Ladds Garden Centre, Bath Road: Transport Statement Addendum

Ref: TW/BB/ITB210007-005B TN
Date: 21 January 2026

- 1.1 Westbourne Homes has appointed i-Transport LLP to provide highways and transportation advice in relation to a full planning application for a residential development of 19 homes at the site of the Ladds Garden Centre in Hare Hatch, Wokingham.

Image 2.1: Visibility Splays – Site Access and Proposed Refuge Island

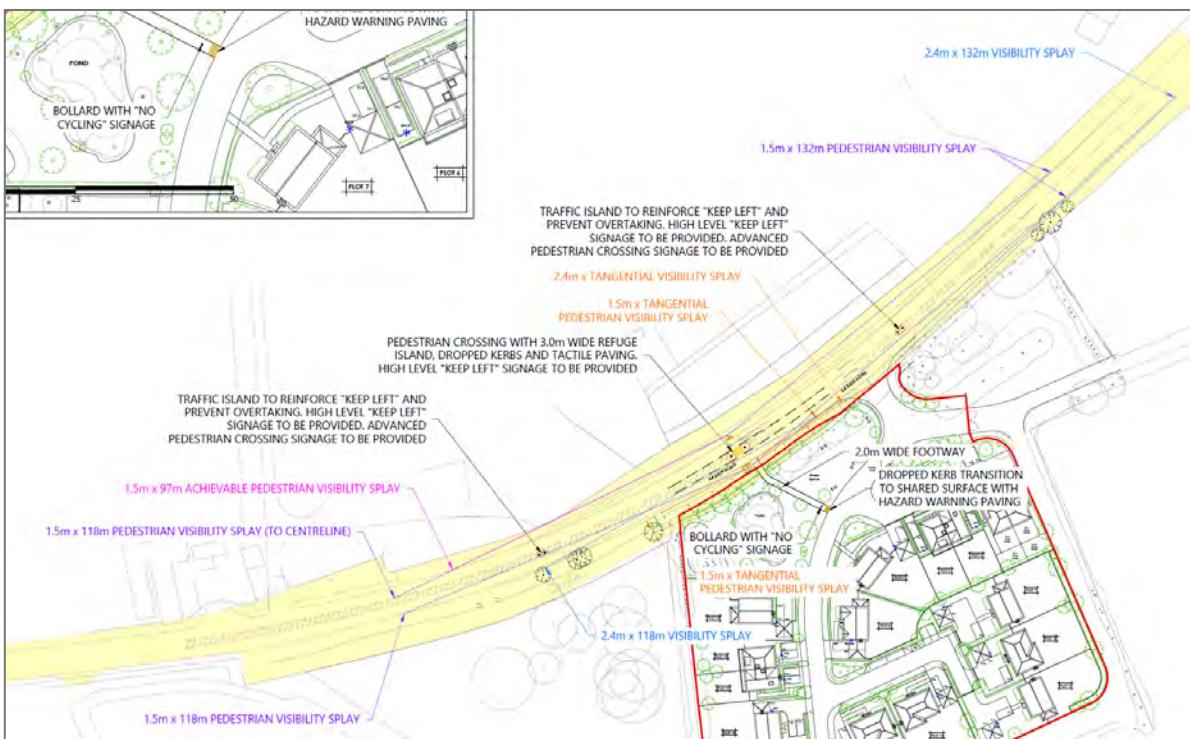
2.2.1 In response to comments made by WBC Highways, the visibility splays at the site access junction and the proposed refuge island crossing have been revised to assess visibility along the tangent of the bend on the A4 Bath Road. The revised visibility splays are presented on i-Transport drawing no. **ITB210007-GA-004F**, extracted at **Image 2.1**.

2.2.2 The drawing demonstrates that the tangential visibility splays can be delivered entirely within the public highway.

2.3.1 To address comments raised by WBC Highways, the width of the proposed refuge island has been increased to 3.0m. At this width, the refuge island will provide sufficient protected space for a cyclist to wait before turning onto the A4 Bath Road and provides a material improvement for access onto/off the A4 Bath Road for cyclists at the proposed development.

2.3.2 The revised design for the proposed refuge island is presented in i-Transport drawing no. **ITB210007-GA-004F**, which is extracted as **Image 2.1**.

Image 2.2: Concept Plan for the Relocation of the 40mph Speed Limit on A4 Bath Road

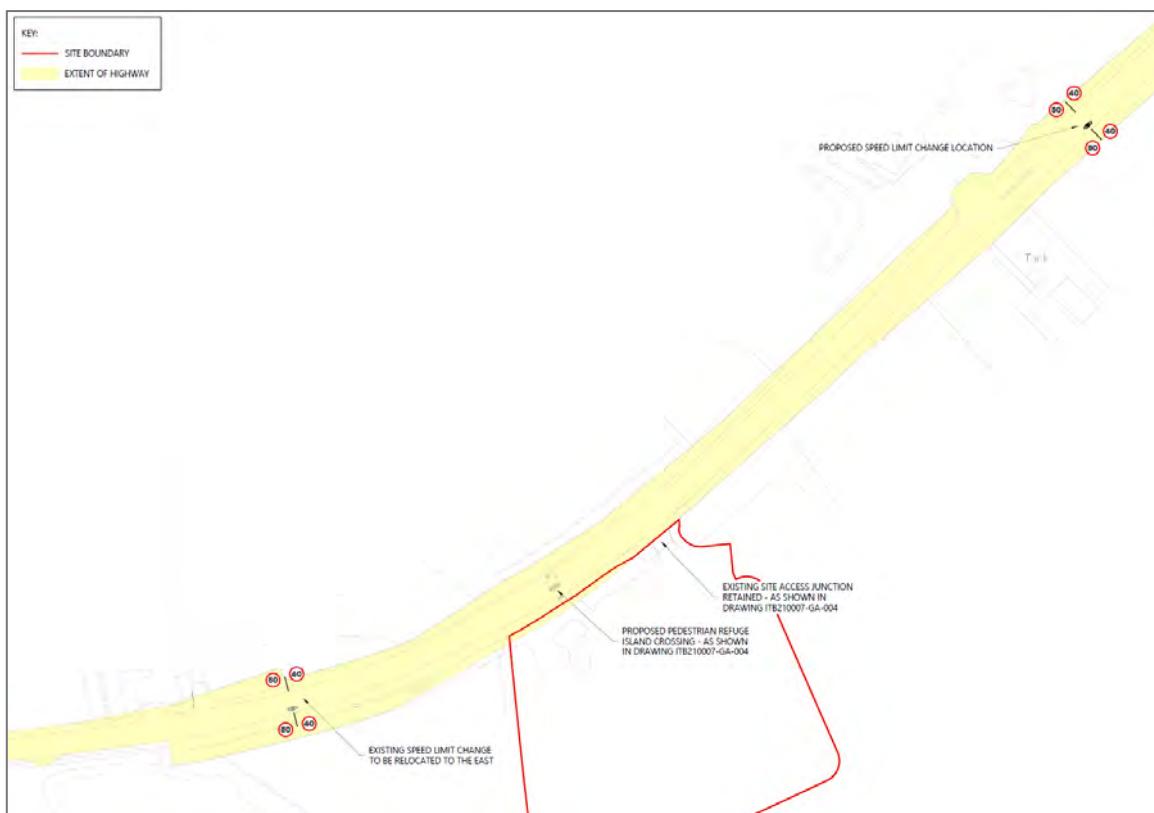
2.4.2 Notwithstanding this, the Applicant recognises that observed vehicle speeds along the A4 Bath Road in the vicinity of the site are well below the sign-posted 50mph speed limit and is advocating for the potential reduction in speed limit along this section of the A4 Bath Road. Whilst this speed limit change is not necessary to deliver a safe and suitable access arrangement to the proposed development, the Applicant is nonetheless willing to fund the amendment to the existing TRO to extend the 40mph speed limit east past the site access junction. This will provide a betterment to the existing street environment for pedestrians, as well as providing significantly improved conditions for on-street cycling and for general highway users.

2.4.3 An initial concept for how the 40mph speed limit amendment could be introduced along the A4 Bath Road is presented as **Image 2.2**. The funding contribution to amend the TRO can be secured within an appropriately worded obligation within the S106 Agreement.

Image 3.2: Additional Swept Path Analysis – Refuse Vehicle and Large Car

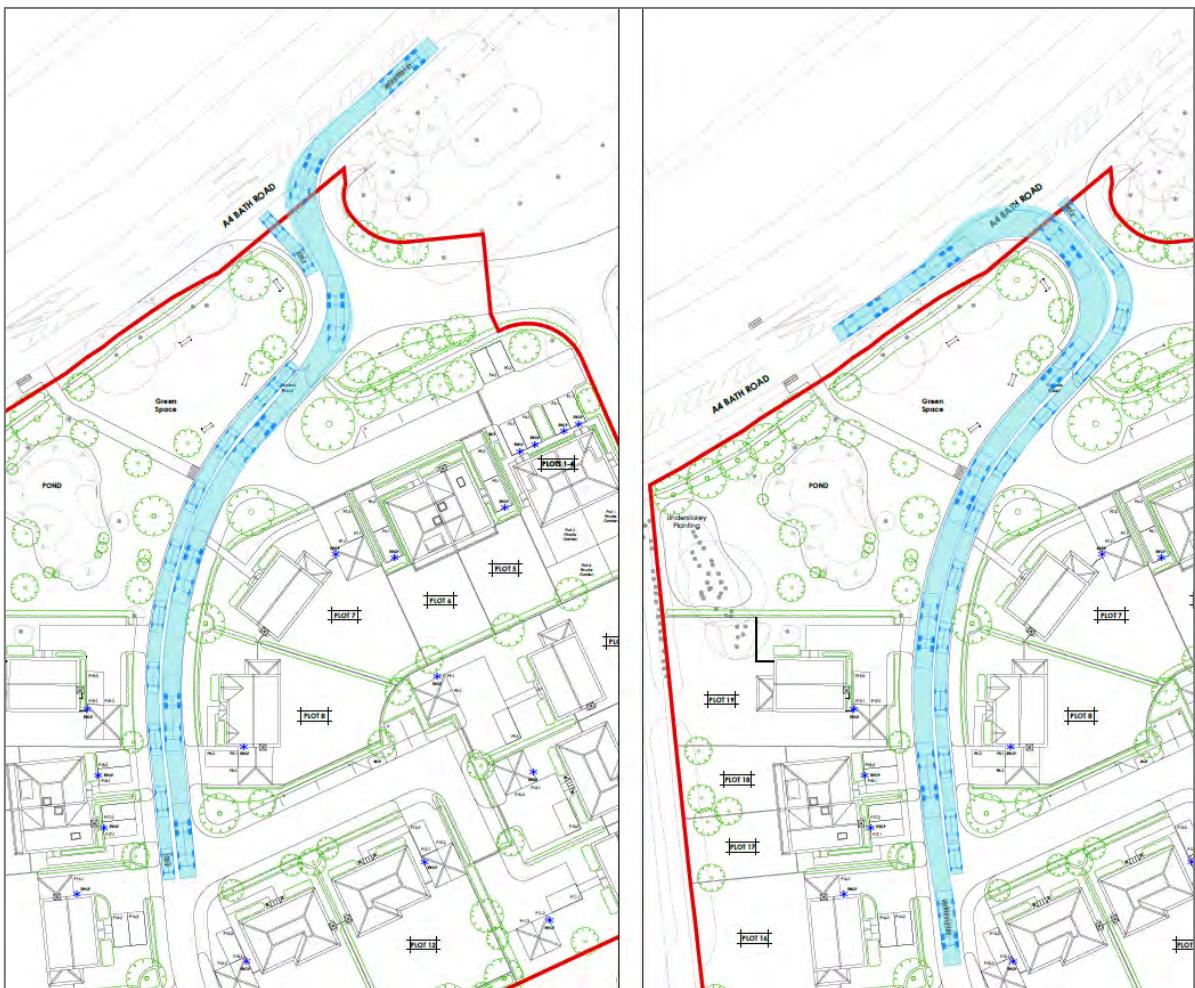
3.4.6 The additional swept path analysis of a refuse vehicle passing a large car within the development is presented as i-Transport drawing no. **ITB210007-GA-008A**, also presented as **Image 3.2**.

3.4.7 Guidance within the Manual for Streets is clear that street layouts within new developments should not be dominated by the requirements of large service vehicles and that where traffic flows are low, it should be assumed that service vehicles are able to use the full width of available carriageway to manoeuvre¹.

3.4.8 Notwithstanding this, the swept path analysis demonstrates that a large car and refuse vehicle are able to pass simultaneously on access to the site from the A4 Bath Road, and along the length of the primary shared surface street within the proposed development.

Image 3.3: WBC Parking 'Boundaries' – WBC Parking Calculator Spreadsheet

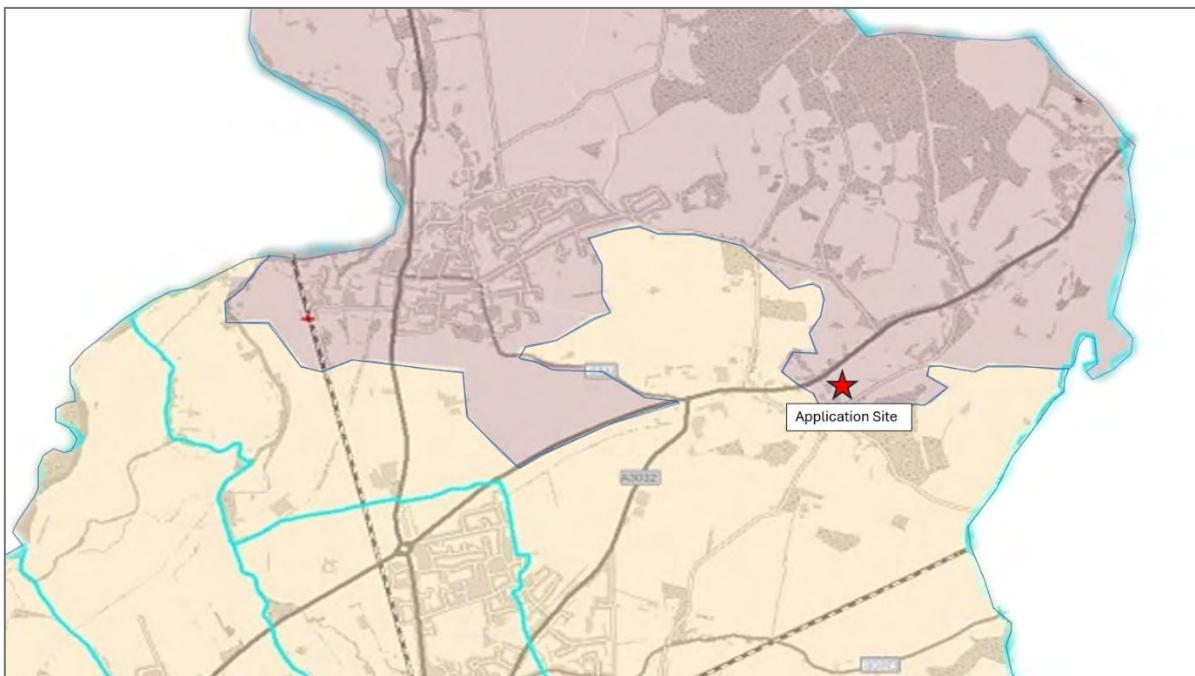
3.5.1 With regards to the application of WBC's Parking Standards, the application site is located on the boundary between a 'Village' and a 'Town and Fringe' location, as shown on **Image 3.3**. On the basis of the below, a 'Village' location was selected for the calculation of the parking requirements for the proposed development.

3.5.2 Notwithstanding this, and at the request of WBC Highways, the proposed car parking provision has been amended to reflect a 'Town and Fringe' location, and therefore has been increased to include:

- Two additional visitor parking spaces (providing four in total); and
- Two unallocated parking spaces.

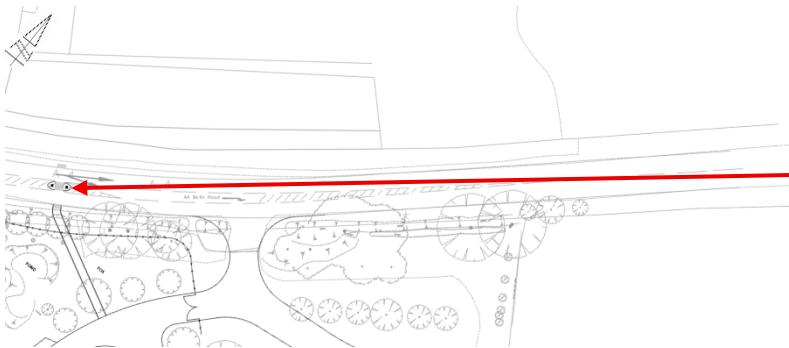
A.2	GENERAL
A.2.1	PROBLEM
Location:	A4 Bath Road
Summary:	Westbound motorists may not become aware of the proposed island at a safe distance
Acc Type:	Vehicle to pedestrian and / or loss of control type collision
<p>The A4 Bath Road is subject to a 50mph speed limit and follows a bend as it passes the western frontage of Ladds Garden Village. A right turn lane is formed within the carriageway to allow access to the Garden Village, which is 2.6 metres wide and formed with a taper to the east. The proposals include the provision of a pedestrian refuge island within the area of central hatching immediately to the west of the right turn lane. The scheme drawing illustrates that a 132 metre visibility slay is achievable to the east of the uncontrolled crossing point and therefore it is clear that westbound motorists will have visibility to the physical island in accordance with 85th percentile speeds. The Audit Team have concerns, however, that due to the bend in the road, the proposed keep left bollards won't be facing approaching westbound traffic and therefore the entire reflective face will not be clearly visible. As such, westbound motorists may not become aware of the physical island at a safe distance, particularly during the hours of darkness which could lead to a vehicle colliding with the physical island and a vehicle to pedestrian or loss of control type collision.</p>

<p>RECOMMENDATION:</p> <p>It is recommended that a splitter island is provided within the taper to the east of the right turn lane which will be directly in front of and therefore clearly visible to westbound motorists.</p>	
<p>Location Plan:</p>  	
A.2.2	PROBLEM
Location:	A4 Bath Road
Summary:	Eastbound motorists may not become aware of the proposed island at a safe distance
Acc Type:	Vehicle to pedestrian and / or loss of control type collision
<p>The A4 Bath Road is subject to a 40mph speed limit within the village of Hare Hatch where a number right turn lanes are accommodated to allow access to amenities and properties off both sides of the carriageway. Those right turn lanes are separated by areas of central hatching to form consistent eastbound and westbound lane widths. The carriageway follows a bend towards</p>

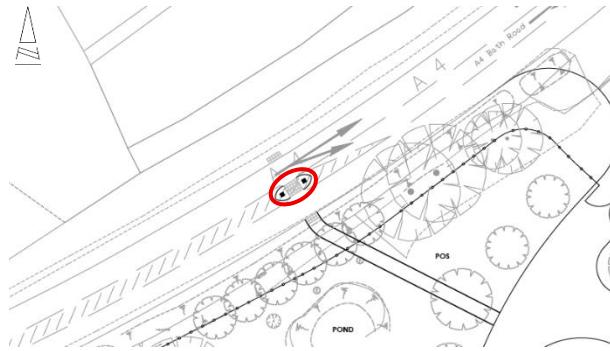
A.2.3	PROBLEM
Location:	A4 Bath Road
Summary:	Motorists may not become aware of the proposed island at a safe distance
Acc Type:	Vehicle to pedestrian and / or loss of control type collision

The A4 Bath Road observes a high percentage of HGV's as well as other high sided vehicles and accommodates a number of traffic islands that benefit from keep left bollards as well as illuminated high level signs. The proposals include the provision of an uncontrolled crossing point that benefits from a refuge island. The scheme drawings illustrate that keep left bollards are to be installed on the physical islands, however, no high level signage is proposed. The Audit Team have concerns that motorists following high sided vehicles will not become aware of the proposed physical island

at a safe distance and may attempt to overtake which could lead to a vehicle colliding with the island and a loss of control type collisions.

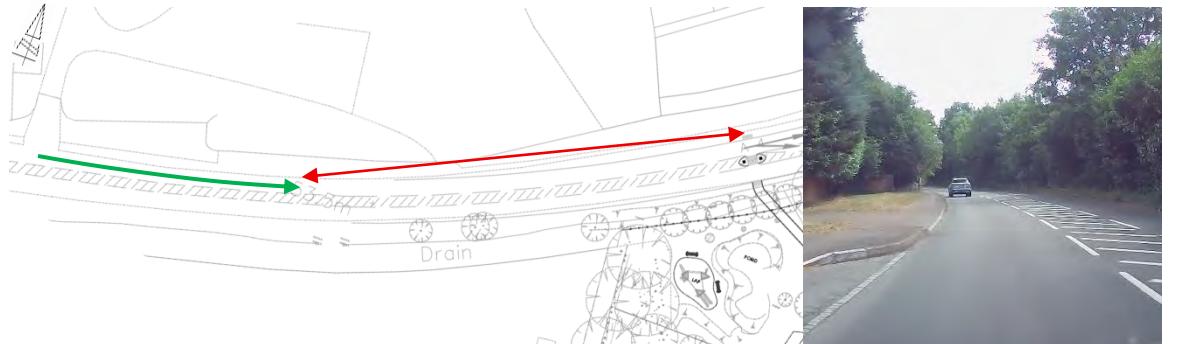
A.3	JUNCTIONS
<i>No Road Safety Concerns regarding JUNCTIONS have been raised at this stage</i>	
A.4	WALKING, CYCLING AND HORSE RIDING
A.4.1	PROBLEM
Location:	A4 Bath Road
Summary:	Intervisibility between a pedestrian and eastbound motorist is limited
Acc Type:	Vehicle to pedestrian type collision

The A4 Bath Road that is subject to street lighting in proximity to the village of Hare Hatch where a 40mph speed limit is present which increases to 50mph for eastbound traffic, at a point circa 160 metres to the west of the priority access and 115 metres before the right turn lane associated with Ladds Garden Village. The characteristics of the A4 Bath Road appear to change at the existing change in speed limit becoming more rural in nature with foliage both sides of the carriageway. The proposals include the provision of an uncontrolled crossing point immediately to the west of the existing right turn lane associated with the Ladds Garden Village, at a location immediately adjacent to an existing street lighting column. The scheme drawing illustrates that visibility slays in accordance with 85th percentile speeds are achievable from each crossing point, however, the 118 metre splay to the west of the northern uncontrolled crossing point extends to the road centreline rather than the channel line. It is noted that a splay of 97 metres is achievable to the channel line. The Audit Brief identifies that all visibility splays are to be cleared and maintained clear of obstructions and that the 118 metre splay to the road centre line represents a Departure from Standard (DfS), as the splay should extend to the nearside channel line. The proposed uncontrolled crossing benefits from a refuge and therefore users cross each 3.5 metre lane individually. As stated within Chapter 6 of Traffic Signs Manual, a lower walking speed of 1.0m/s is utilised to calculate timings for crossings which when applied to the lane width, would

mean that a pedestrian is expected to be within the carriageway for 3.5 seconds. This is increased to 4.4 seconds when based on UCL research which identified that the average walking pace of an elderly pedestrian aged over 65 is 0.8m/s. It can be determined that an eastbound vehicle approaching the proposed uncontrolled crossing at the 85th percentile speed observed of 43.9mph, will take 5 seconds to travel the 97 metres. It is therefore clear that, provided the visibility splays illustrated are maintained clear, a pedestrian should have an adequate level of visibility to cross the 3.5 metre eastbound lane based on 85th percentile approach speed. It is noted, however, that traffic could legally travel at speeds in excess of the 85th percentile speed recorded which would render the achievable level of visibility insufficient. An eastbound motorist approaching a pedestrian who is crossing the eastbound lane will have clear visibility of the pedestrian within the carriageway ahead even during the hours of darkness, due to the presence of street lighting column, and should therefore adjust their speed accordingly. The Audit Team have concerns, however, that the route characteristics of the A4 Bath Road are to remain unchanged and rural in nature. Eastbound motorists are unlikely to expect a pedestrian to cross the carriageway at this location which could lead to heavy braking and loss of control type collisions.

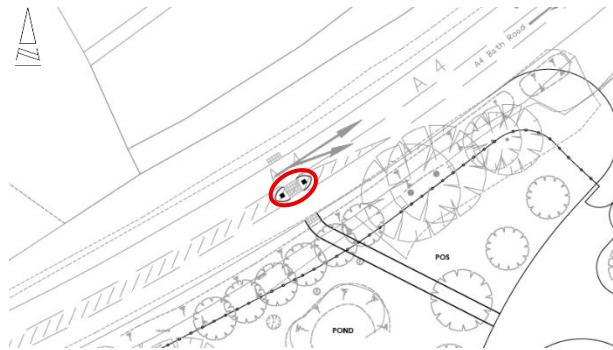
A.4.2	PROBLEM
Location:	A4 Bath Road
Summary:	Proposed refuge is inadequate to accommodate cyclists
Acc Type:	Vehicle to cyclist type collision
<p>The A4 Bath Road observes a traffic flow of circa 17,000 vehicles per day with circa 1500 vehicles observed in each direction during the peak hours, ref: ATC data provided in the Audit Brief. The proposals include the provision of an uncontrolled crossing point along the A4 Bath Road that is to benefit from a refuge island that is to provide a 2 metre by 2 metre refuge. The proposed refuge will allow pedestrians to each lane of traffic individually and therefore sufficient gaps should be available. The proposed uncontrolled crossing is primarily for pedestrians linking the existing footway to the north with a proposed footpath to the south. The Audit Team have concerns,</p>

however, that cyclists particularly child cyclists travelling between the site and destinations to the east or from destinations to the west and the site, may attempt to utilise the uncontrolled crossing. It is noted that the 2 metre by 2 metre refuge may not be adequate to accommodate a bicycle which could encroach into the through lanes and could be struck by passing traffic leading to a vehicle to cyclist type collision.

It is recommended the depth of the refuge is increased to accommodate a cyclist.
